From: Shaff, Leanna (CI-StPaul)
Sent: Wednesday, April 16, 2014 9:34 AM
To: Moermond, Marcia (CI-StPaul); Vang, Mai (CI-StPaul)
Cc: Neis, Adrian (CI-StPaul)
Subject: FW: 1088 conway
Attachments: 20140303083014832.pdf

From: Niemeyer, George (CI-StPaul)
Sent: Wednesday, April 16, 2014 9:29 AM
To: Shaff, Leanna (CI-StPaul)
Subject: 1088 conway

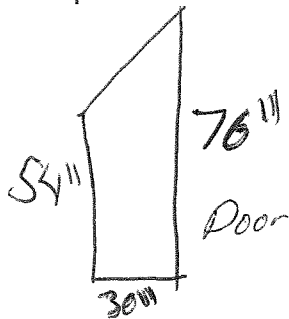
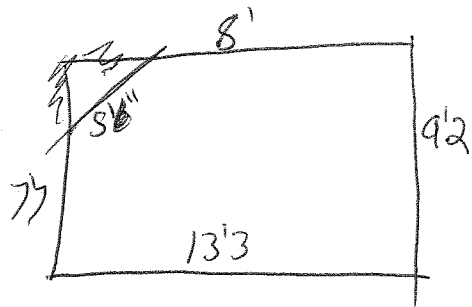
9'2" x 2' over 7' West room

East room

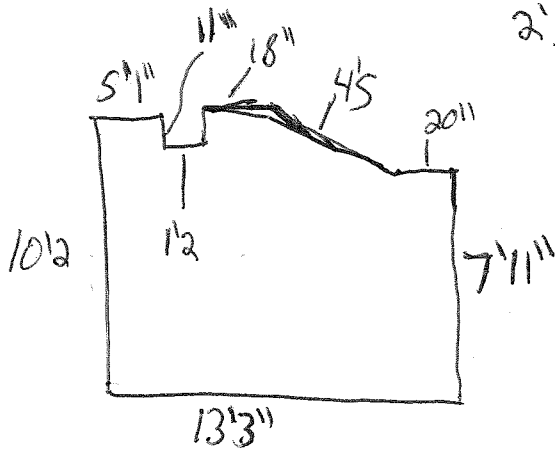
2' x 10'3" over 7'
